Japan Comments for Battery Durability GTR EVE40

24.November.2020

Japan Comment

ii. **Decision:** Base MPR on TEMA model results

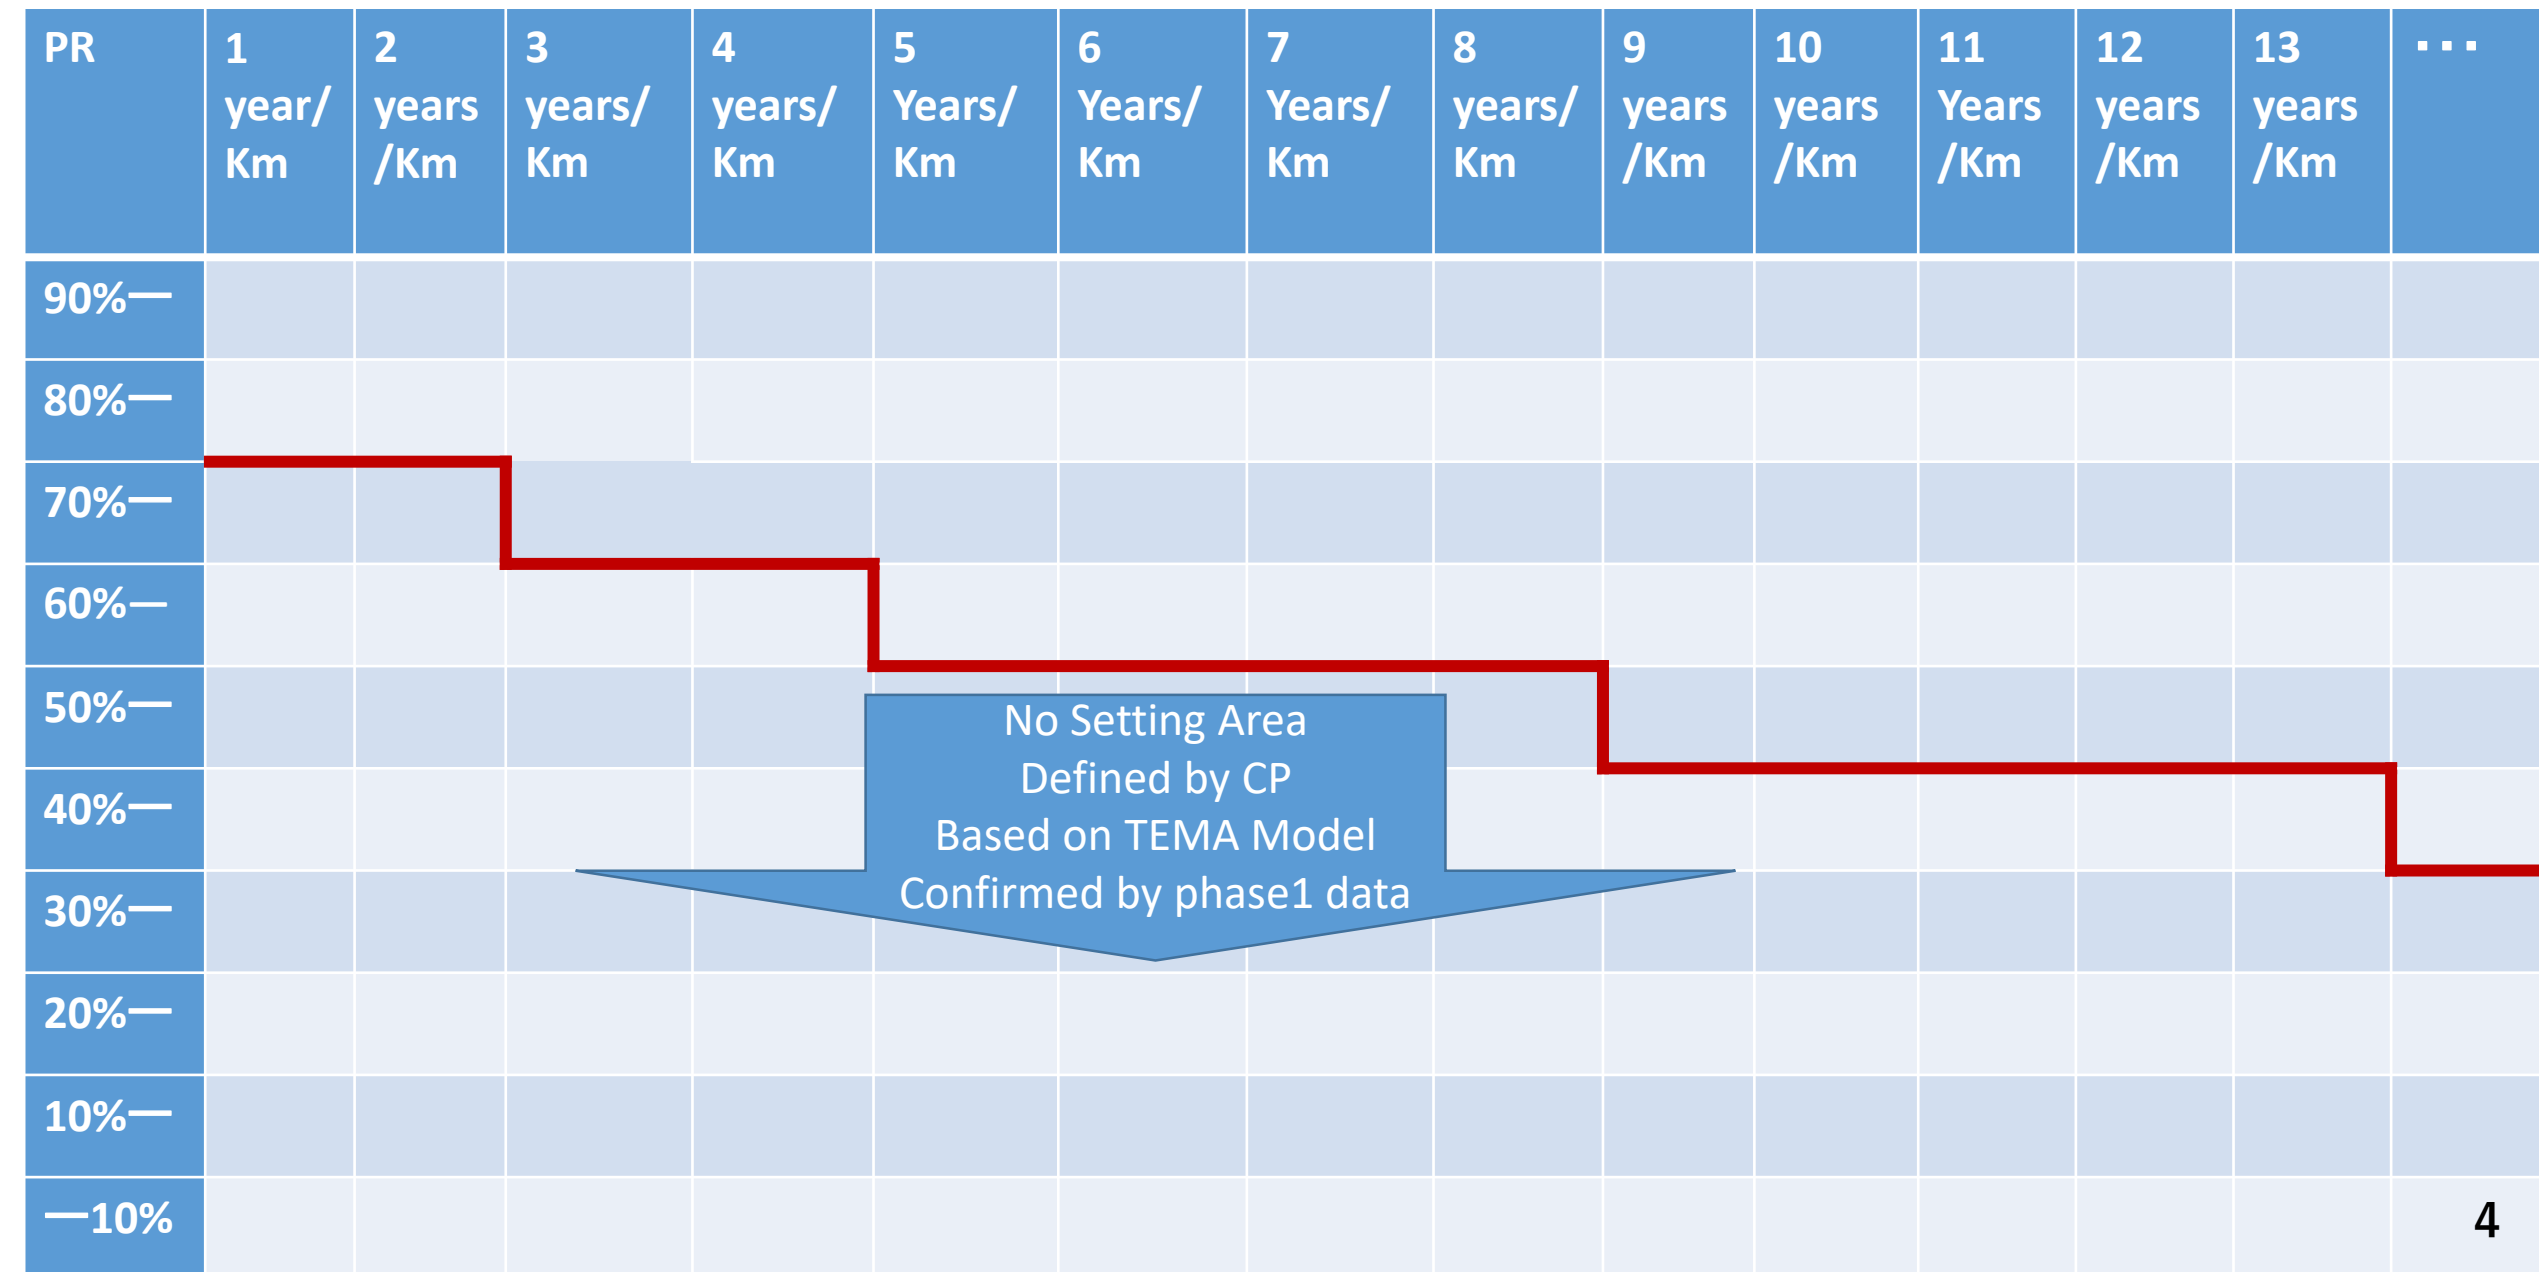
1.Request to continue discussions, using as starting point with the results of the TEMA model.

2.Use Phase 1 data to improve the TEMA model, including better correlation with the market, and further utilize it in Phase 2

Fig. calculated data of 1 OEM (presented in EVE IWG#39)

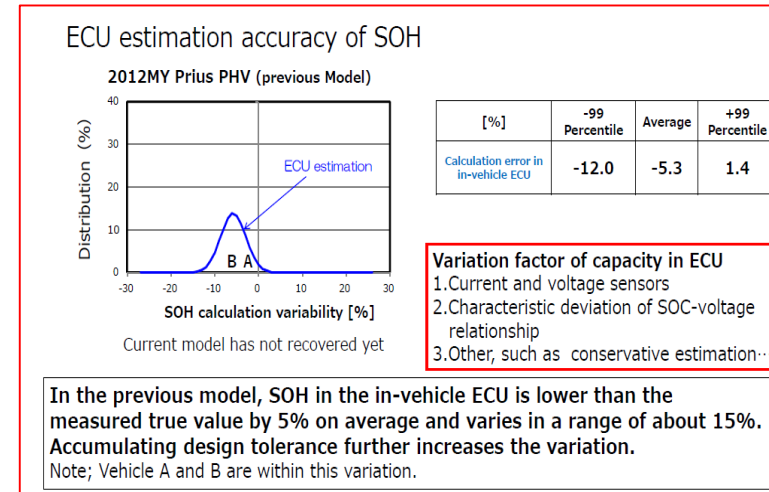
- **There is no change from the stance presented at EVE 39.**
- **Part A validation will use the average analysis, and subsequent periodic checks will use the statistical analysis.**
- **Part A tolerance "z" is indicated as an example;**
 $SOCC_measured + 7\% \geq SOCC_ecu$
 However, 7% is calculated from the data of 1 OEM (fig. shows)

SOCC Calculation General Flow

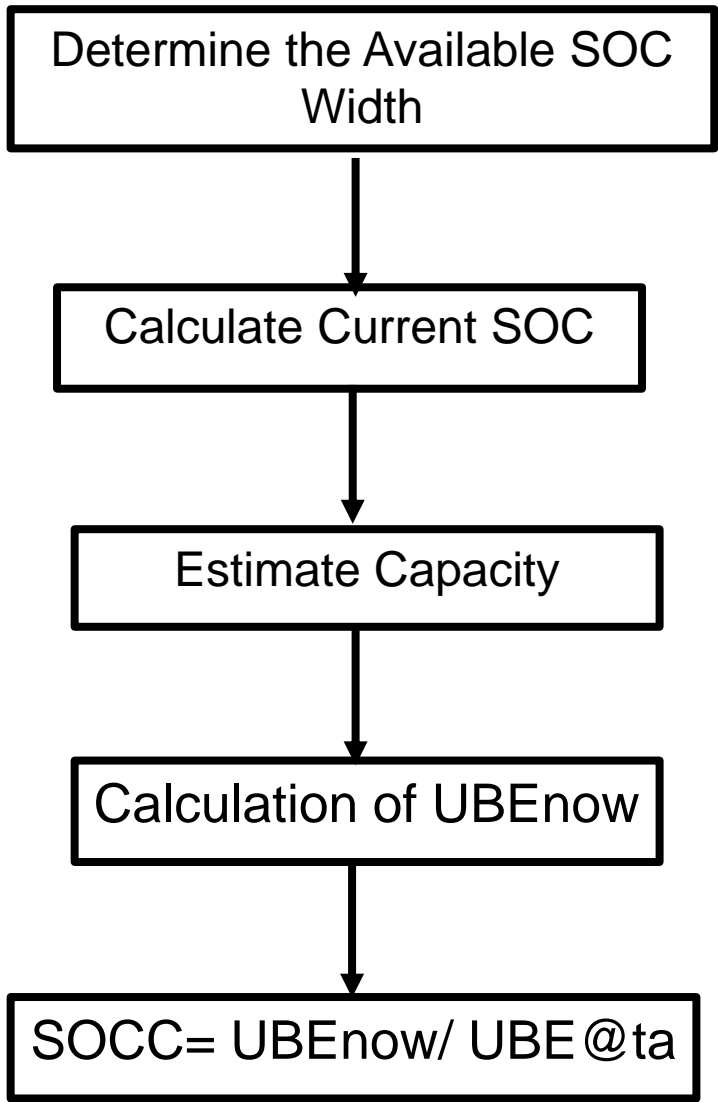
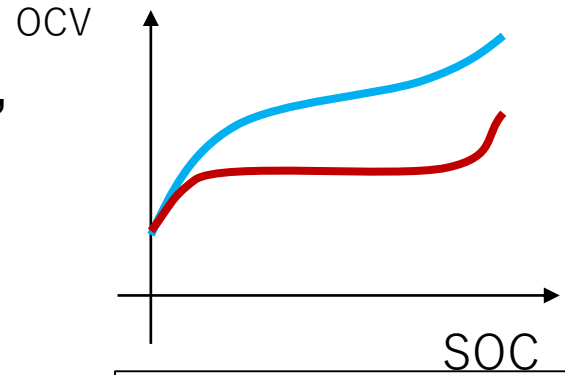
Determined by durability evaluation. SOC width depends on the **type of cell**, but is set for the same flow (calibration)

Depends on the **type of cell**, the calibration flow obtained from the relationship between OCV and SOC (see fig. right) is the same.

Calculated according to basic formula; current integration value/ Δ SOC
SOC width and distribution are different between **EV and PHEV**.
Flow needs some know-how *

<* Example of know-how>
When the capacity is calculated if Δ SOC is small, there is a possibility of large errors due to the large extrapolation range.
Measures: Conditions to allow calculation of capacity IF Δ SOC \geq threshold.
As an adverse effect, frequency of calculation is decreased
Measures:
1) At UBE calculations, the elapsed time since the last capacity calculation will be recorded.
2) Confirm with sufficient frequency against battery degradation speed.

<Japan proposal>

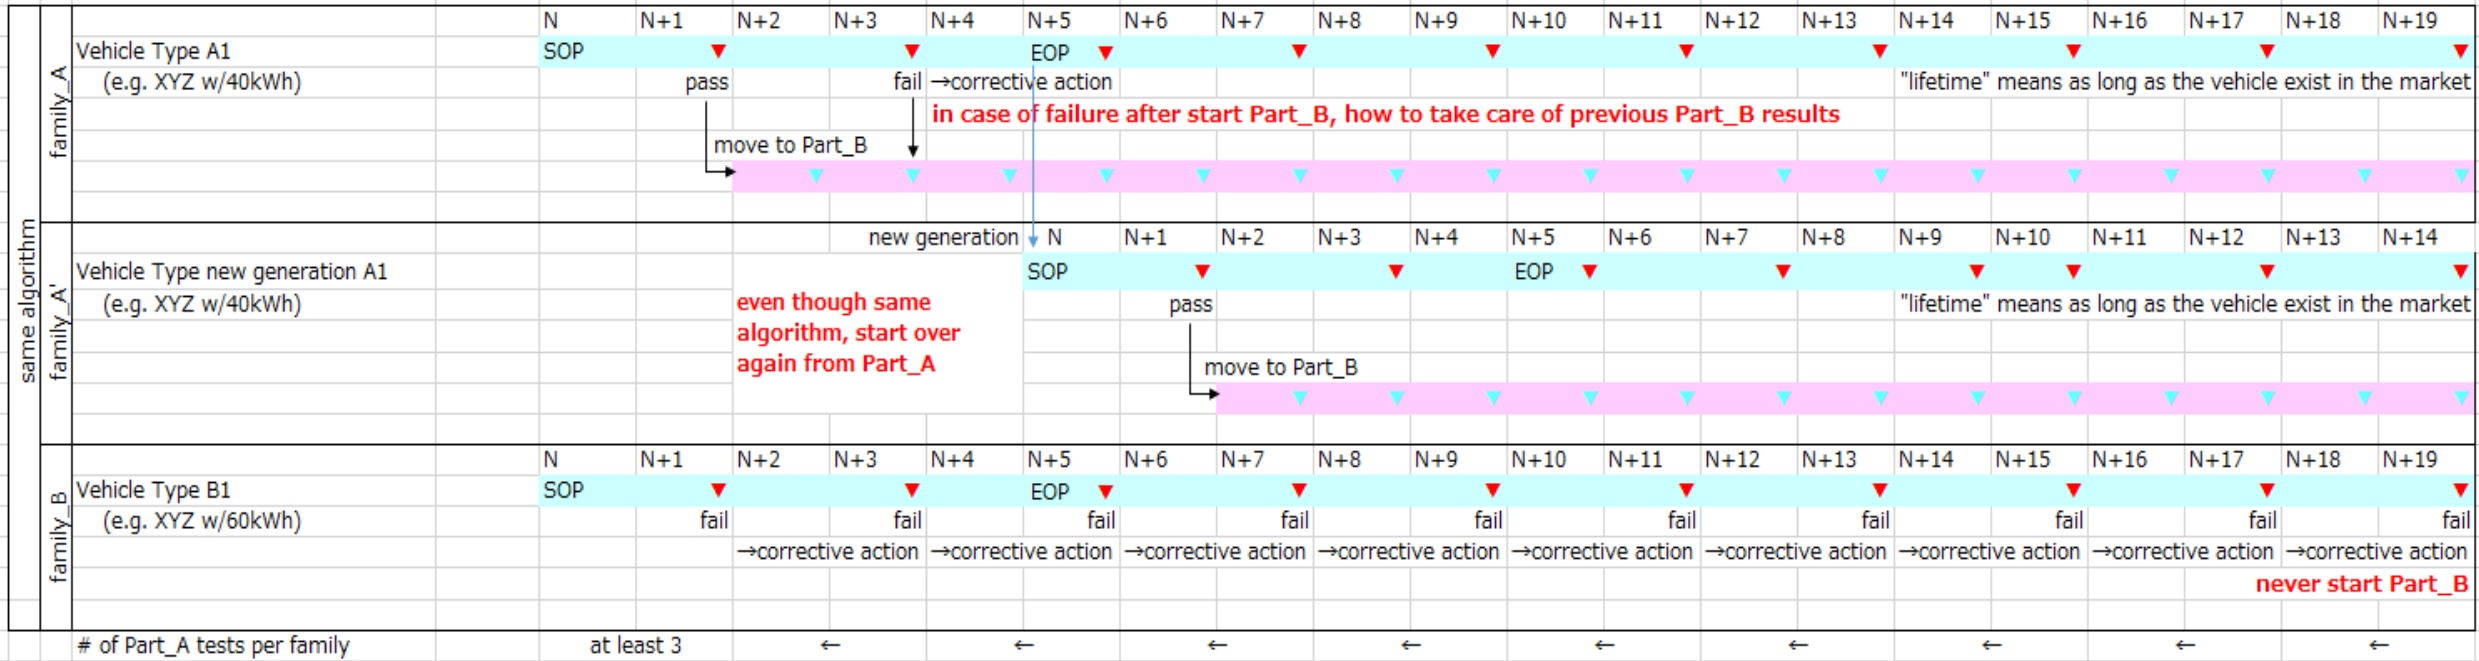
1. Assuming 6 of SOH families, the minimum number of Part A in 5 years for Japan and Europe is **72 units**.

Assumption: Based on WLTP, six SOH families have been introduced both in Japan and Europe, Part A data from Europe and Japan to be shared.

2. After shifting to Part B, 2 out of 6 families will be selectively implemented to reduce the burden. (New proposal)
